RE: Memo to Environmental Report – Decrease in Step Risers at Masonic Temple

Project ID: 3050-02-02

WIS 19 – City of Waterloo – McKay Way to WIS 89 (Monroe Street)

Project Change in Scope – Decrease in step risers

Project Details

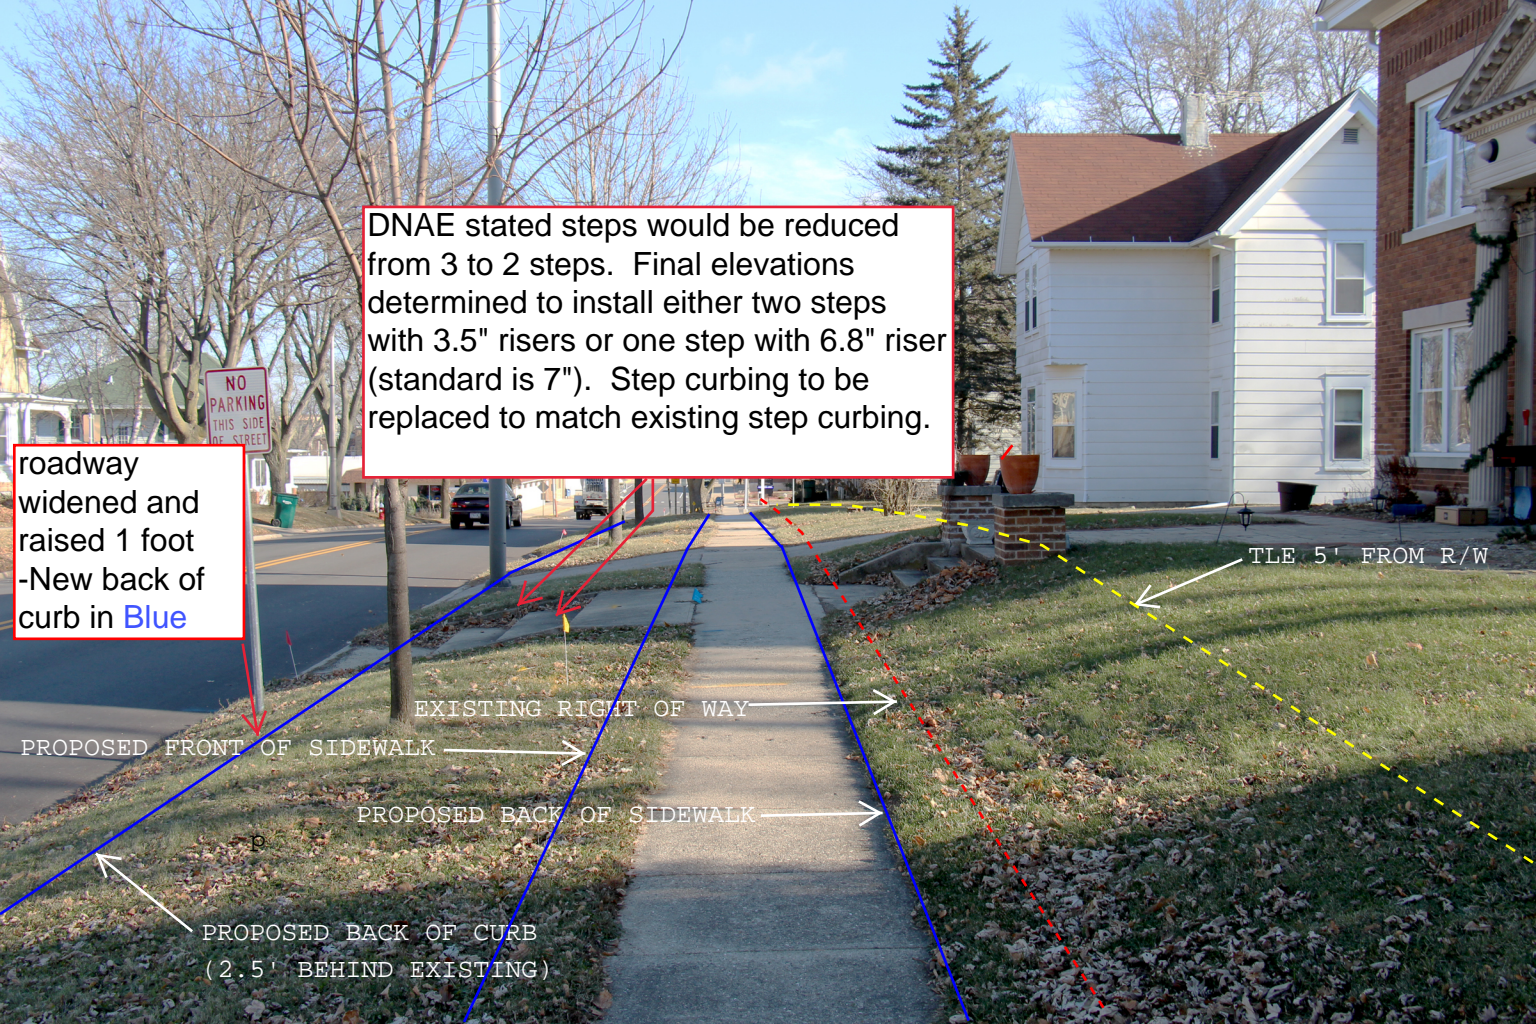
DNAE stated steps would be reduced from 3 to 2 steps. Final elevations determined to install either two steps with 3.5" risers or one step with 6.8" riser (standard is 7"). Step curbing to be replaced to match existing step curbing.

roadway widened and raised 1 foot -New back of curb in **Blue**

PROPOSED BACK OF CURB
(2.5' BEHIND EXISTING)
